PCN/0011

Product range: Han-Modular®

Title: Han® Module Clamp

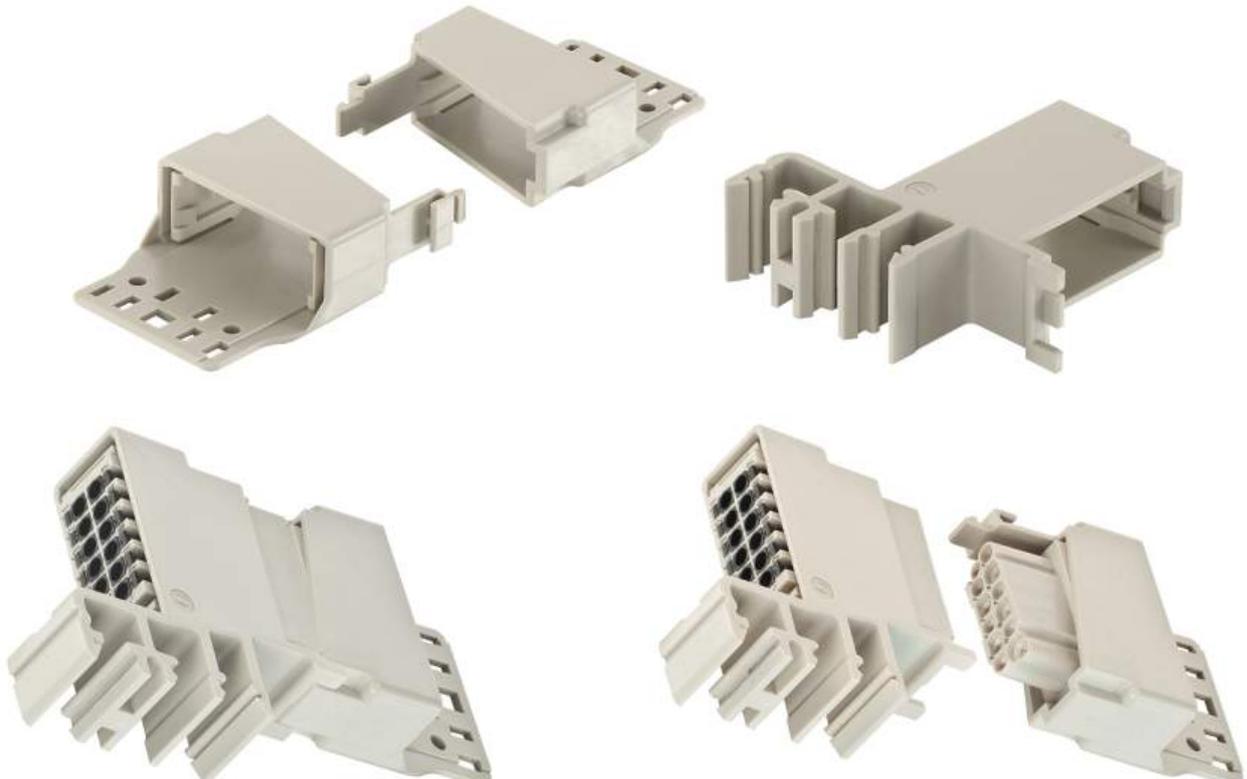
As already announced during the last C&N Forum in September 2012 we want officially inform about the design improvement of the module clamp 09 14 000 0302/ 09 14 000 0303/ 09 14 000 0312/ 09 14 000 0313

The main benefit is that this module clamp is now suitable for all single modules. That means it can be used in many new applications, e.g. in combination with the Han[®] RJ45 Module, the Han[®] MegaBit module, Han-Quick Lock[®] modules, etc.

The second point is that the width is reduced from 25 to 18 mm so that the new module clamp is app 30 % more space saving. Therefore customers can save a lot of space in their switch cabinets.

Finally the handling and functionality has been improved a lot. Now it is possible to connect and disconnect easily with one hand. The insertion and removal of modules is also very easy now.

- Suitable for all single modules module
- The width will be reduced by app 30 % from 25 mm to 18 mm
- Smooth edges
- Easier handling
- Mating and unmating with one hand
- Easy insertion and removal of the modules
- The existing removal tools can be used (09 99 000 0331 + 09 99 000 0828)
- More slots for cable ties
- 100 % mating compatible to the existing module clamps
- No price increase

09 14 000 0302.00	→	09 14 000 0302.01
09 14 000 0303.00	→	09 14 000 0303.01
09 14 000 0312.00	→	09 14 000 0312.01
09 14 000 0313.00	→	09 14 000 0313.01
